申請編號：TPB/A/YL-PH/1070

再次提議渠務報告 (RE-Proposed)

1. 回覆 2025 年 10 月 14 日收到的渠務署意見（簡介）
2.
 - a. 申請人提議的渠管道建造是由申請人自費的。
 - b. 申請人提議的渠管道日後維修保養是申請人的責任。
 - c. 申請人提議的渠管道，也明白地權是政府/私人的。
 - d. 申請人承諾會得到政府部門同意/私人地段同意才會建設渠道工程。
 - e. 申請人聘任 PERRY LEE BUILDING CONSULTANCY COMPANY 公司
作此次渠務顧問

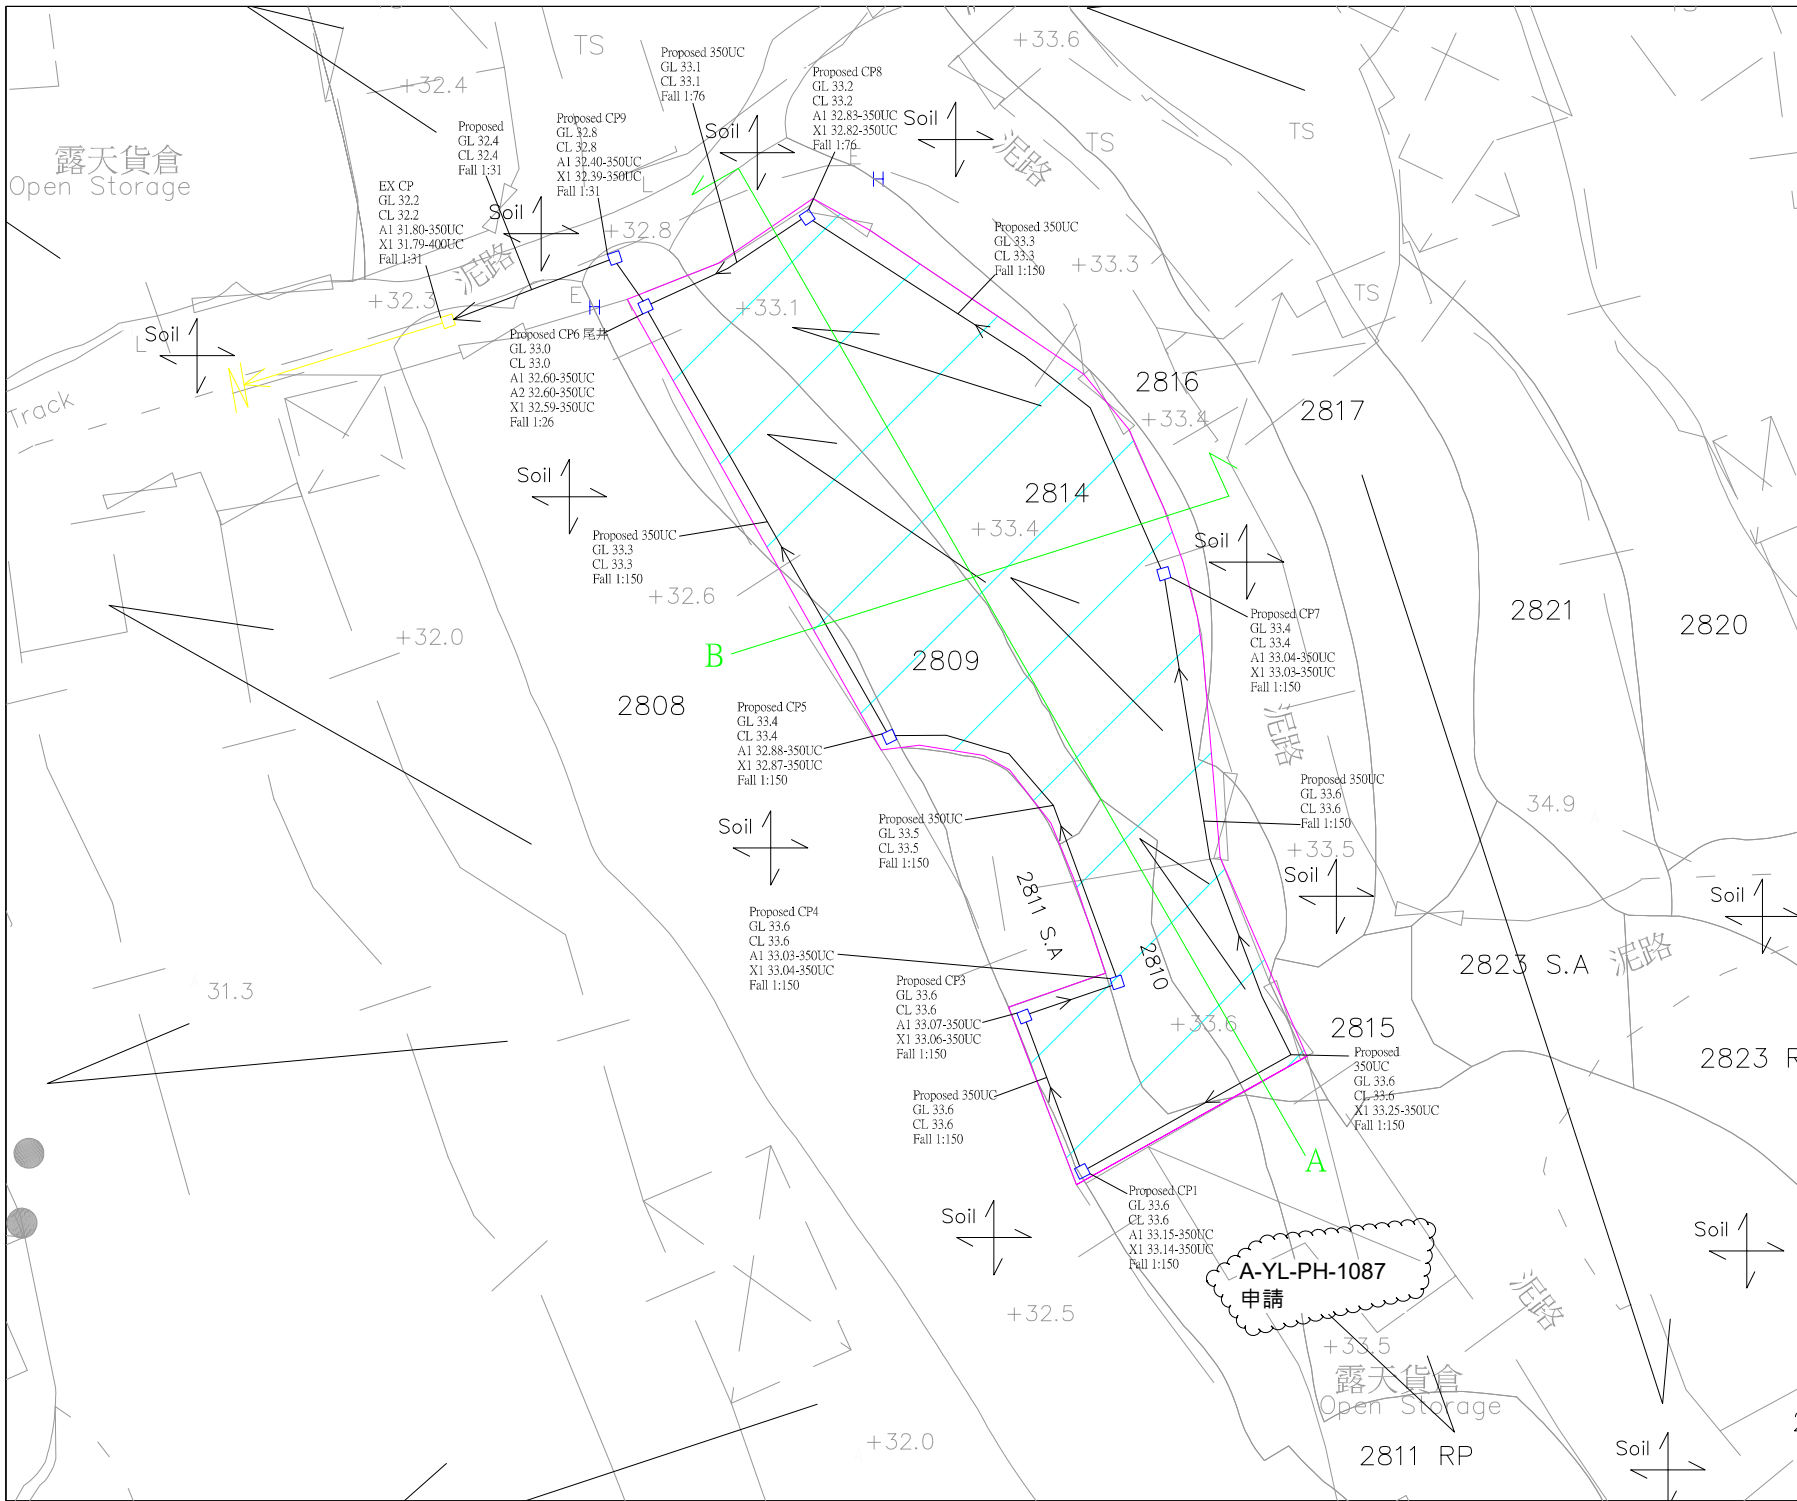
(b) Peripheral surface channels shall be provided along the site boundary to collect the surface runoff accrued on the application site and to intercept the overland flow from the adjacent lands.	使用人申請的位置, UC以做到邊界的

(d) The size and gradient of the proposed/existing drainage facilities to be discharge from the site and/or the overland flow intercepted from the adjacent lands should be indicated in the drainage plan. The applicant should check and ensure the hydraulic capacity of the existing drainage facilities would not be adversely affected by the captioned development.	在b2-1 & b3-1中示, 不會影響周邊地方.

b3-1

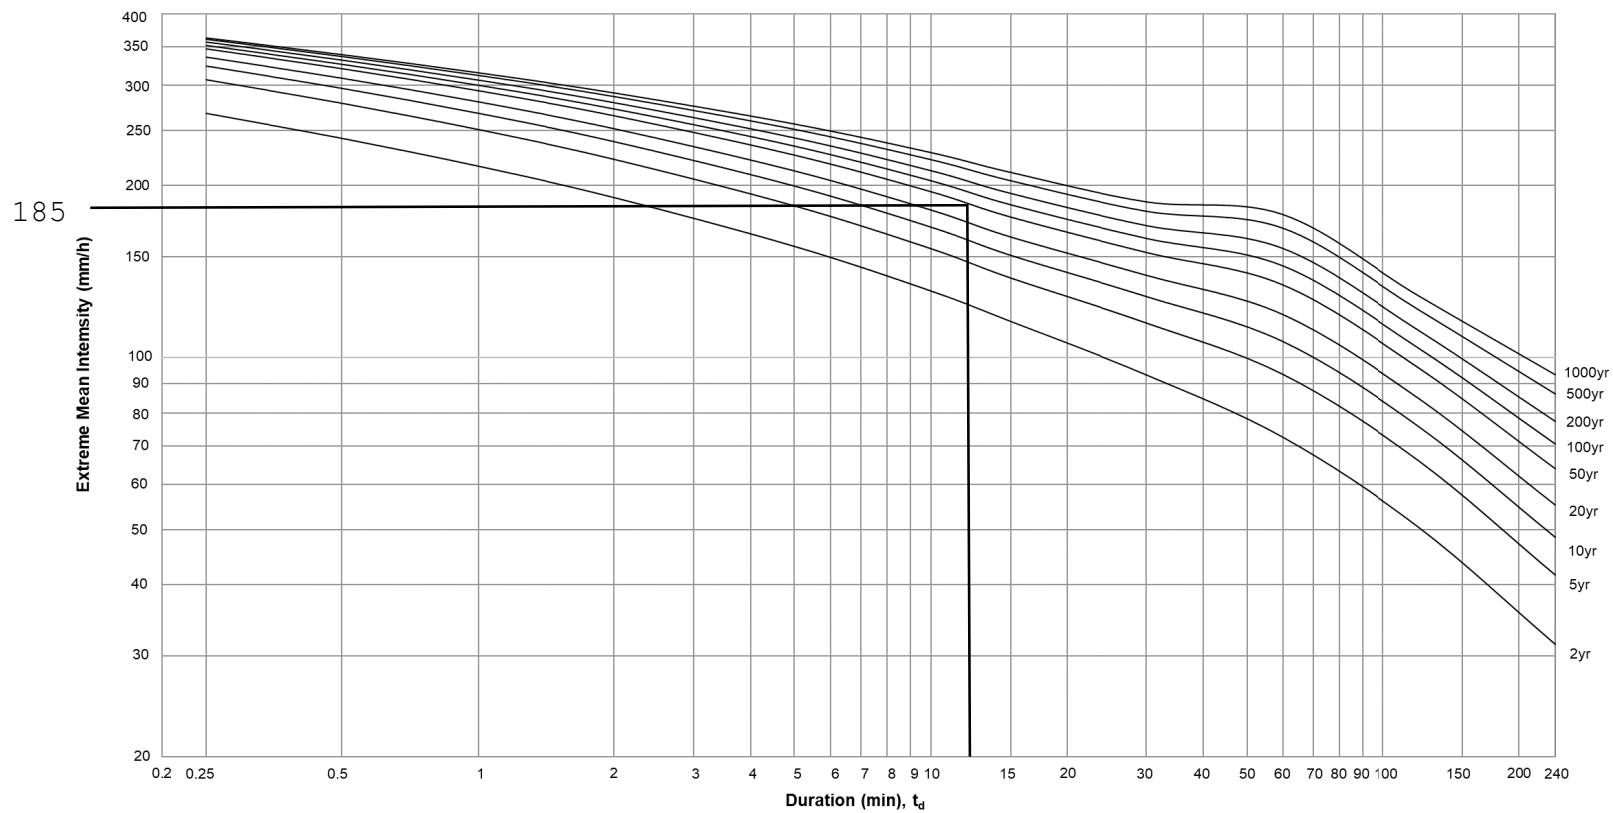
簡介	
Comment	回答
1. I have the following comments on the drainage plan: -	
(a) According to the Stormwater Drainage Manual, the impact of a 50-year event should be assessed to check whether a higher standard than 10 years can be justified.	在b3-1 中示

b4-1

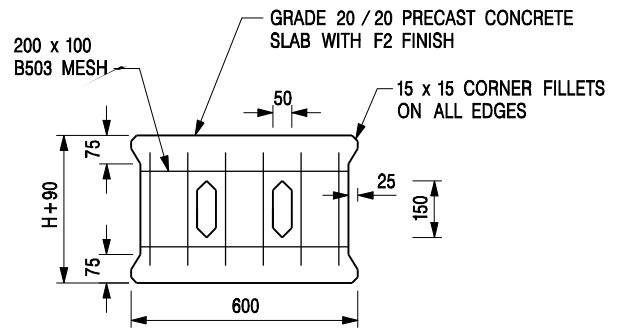
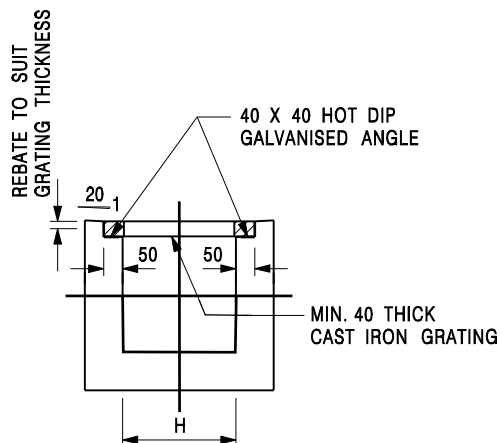
(e) Reference should be made to DSD Technical Note No.1 for the sizes of the proposed u-channels.	在b4-1中示
(f) Where walls or hoarding are erected or laid along the site boundary, adequate opening should be provided to intercept the existing overland flow passing through the site.	知道和明白

b5-1

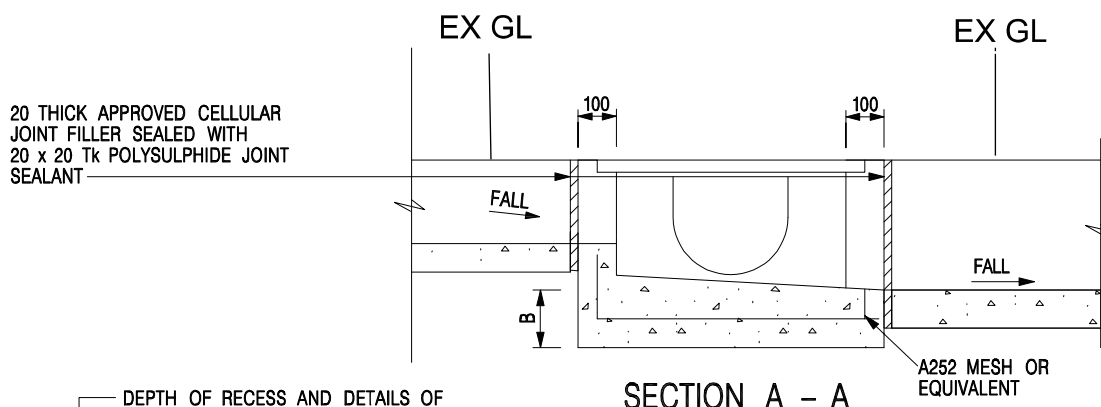
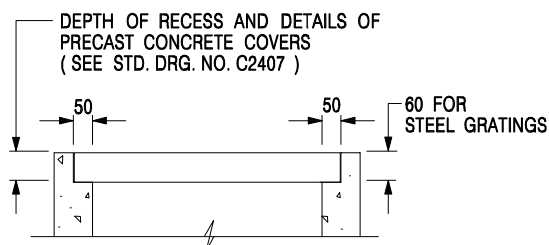
(g) Cross sections showing the existing and proposed ground levels of the captioned site with respect to the adjacent areas should be given.	在d1-1中示
(h) Standard details should be provided to indicate the sectional details of the proposed u-channel and the catchpit/sand trap.	在b4-1, b5-1, b6-1 b7-1 中示

b6-1

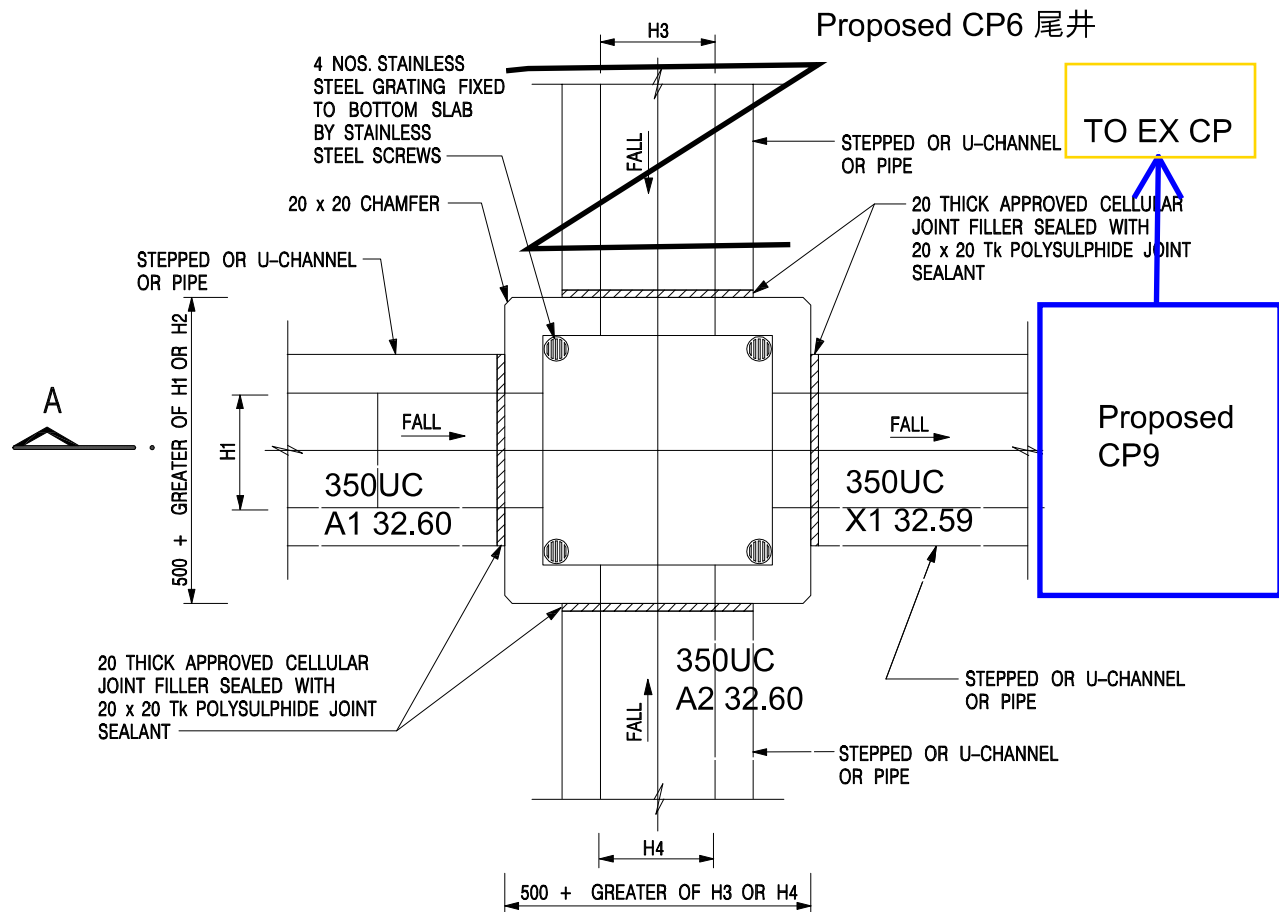
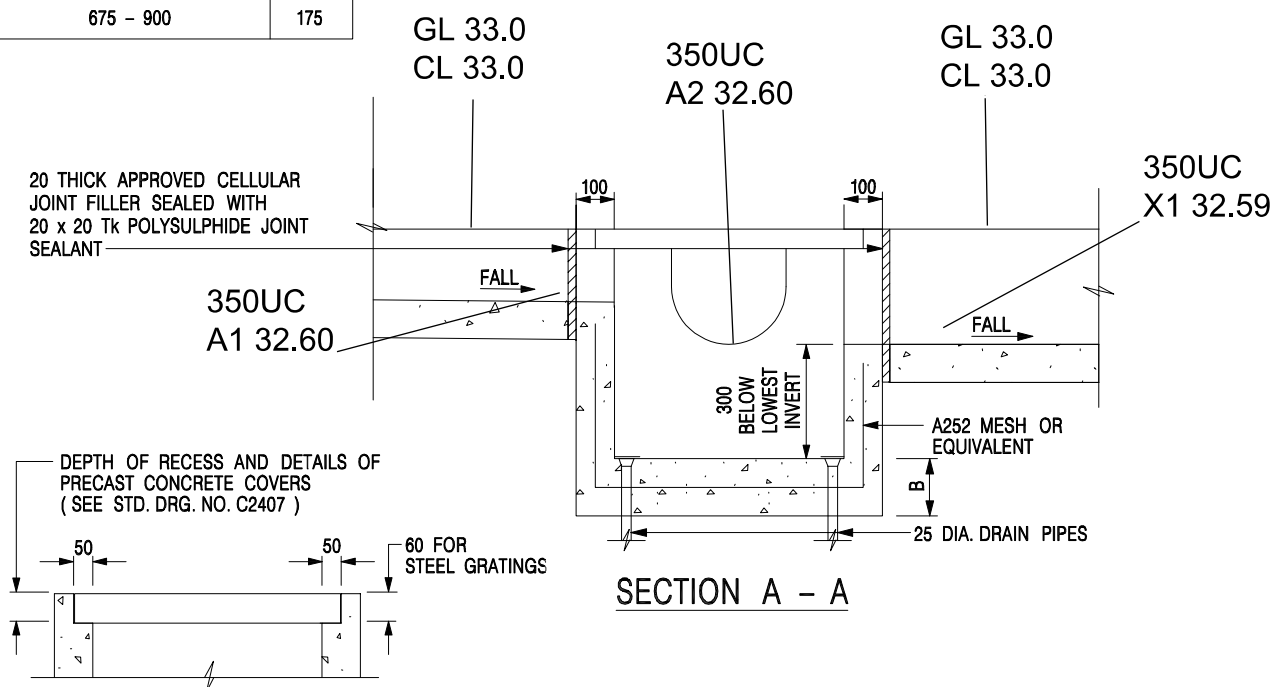
(k) Connection details at discharge point (including cross section) with C.L.. L.L and catchpit/channel bottom level should be shown in the drawing.	在b6-1 & b7-1 中示

c2-1

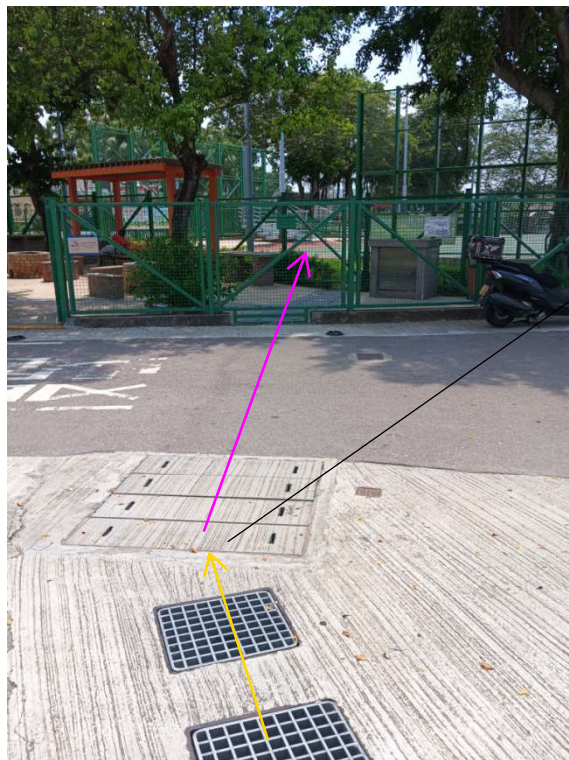
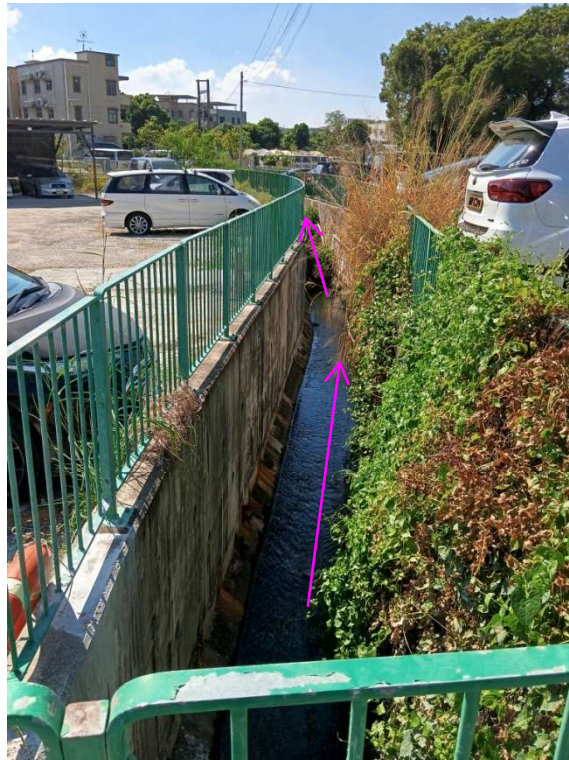
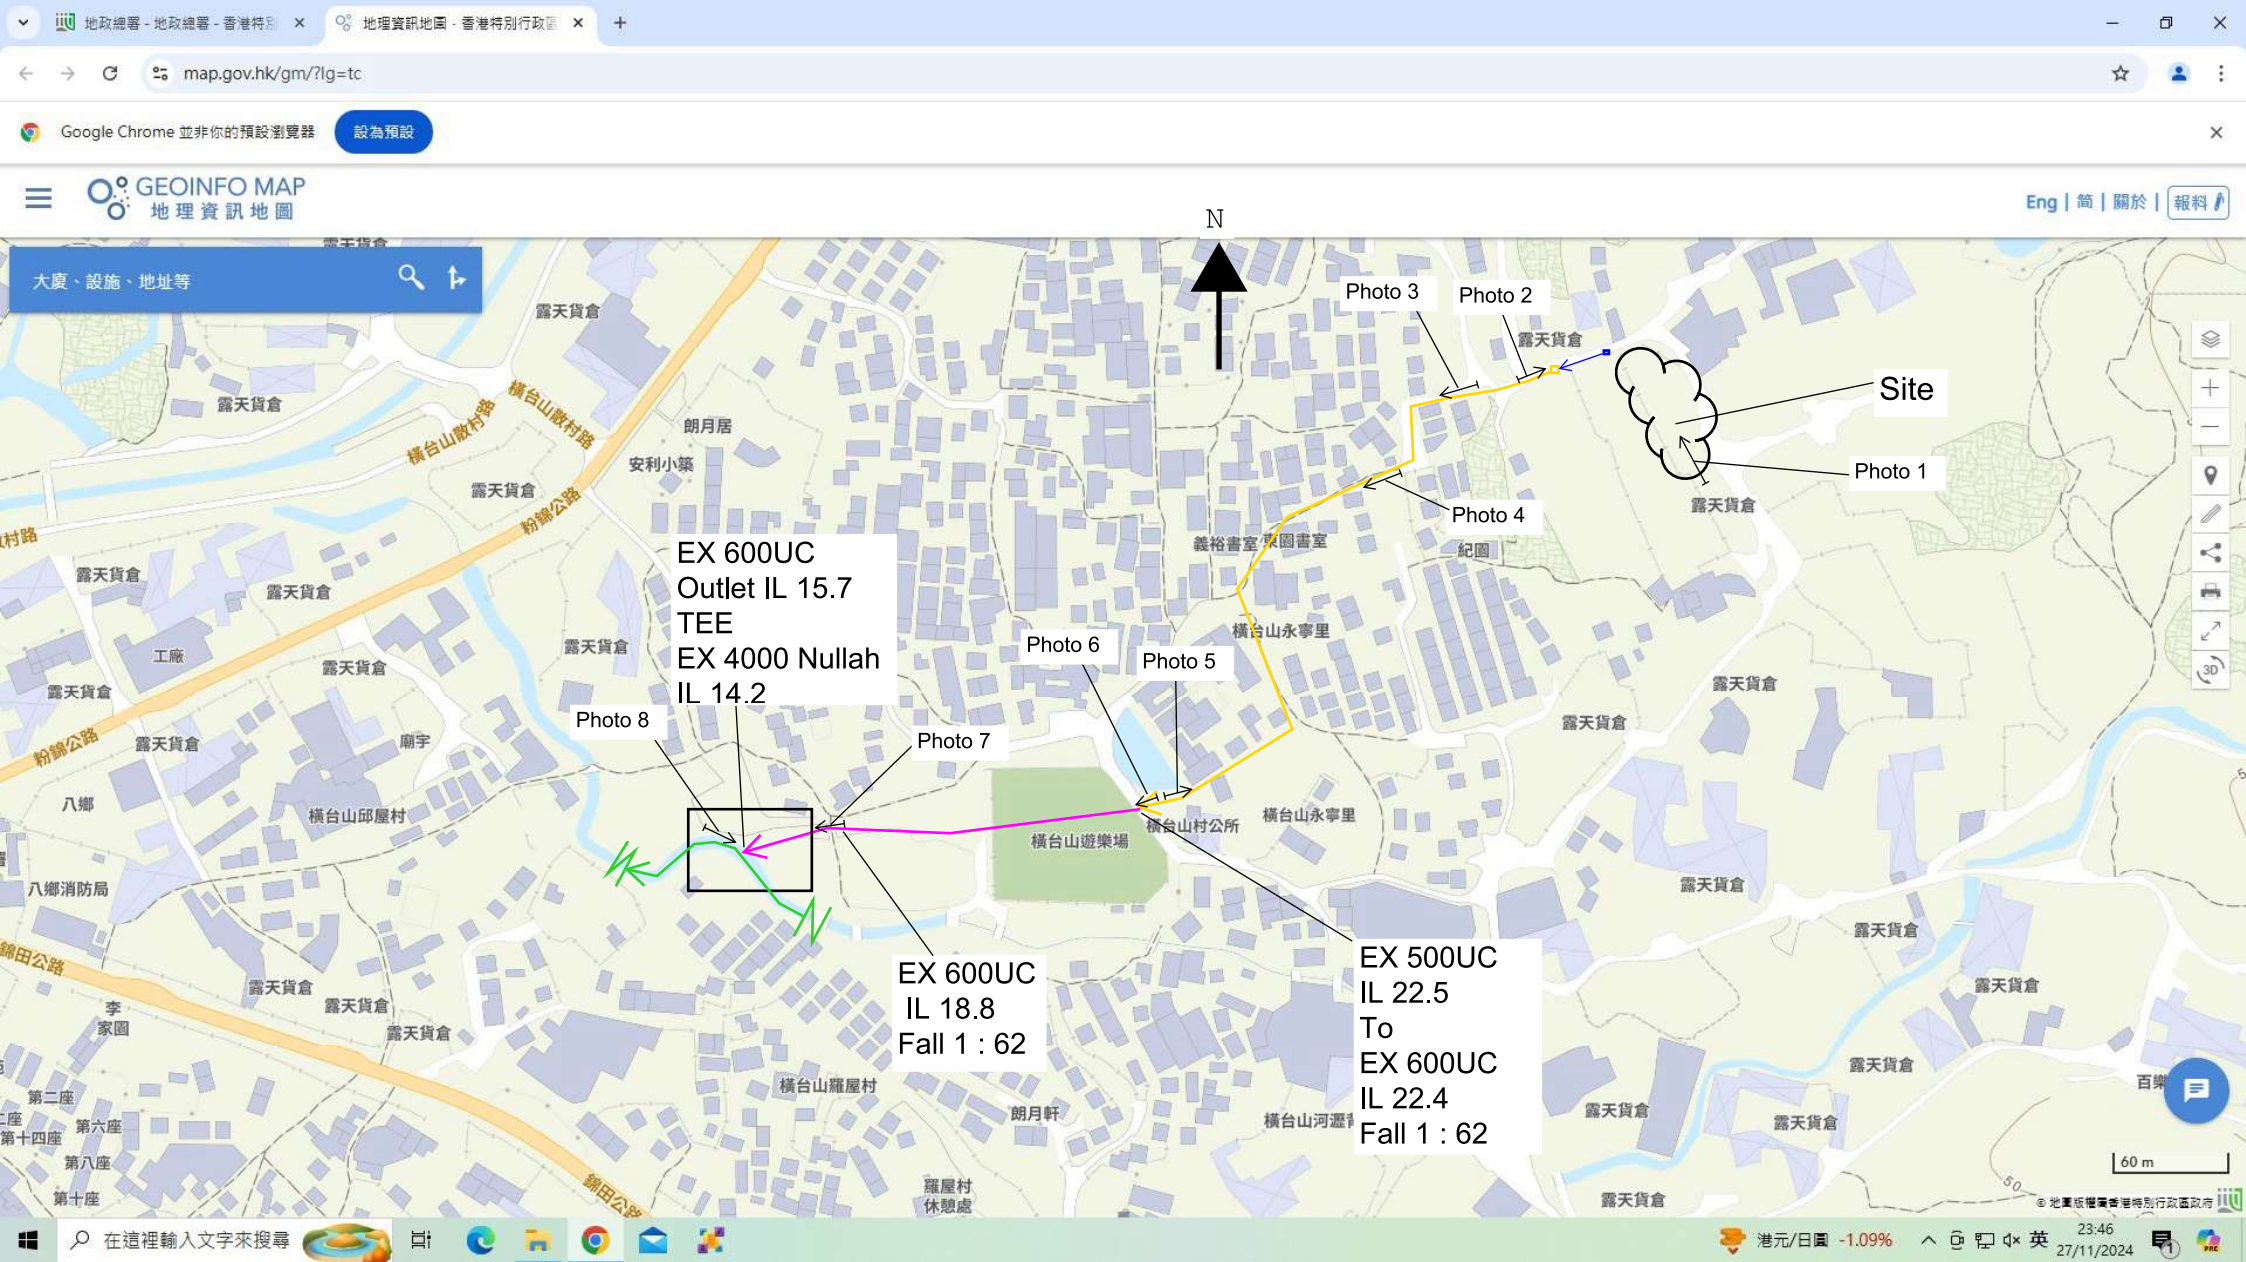
(l) Colour photos to indicate the current conditions of the existing drainage facilities should be included in the submission. The photos taken locations and angles should be shown on the layout plan.	在c1-1 & c2-1 中示
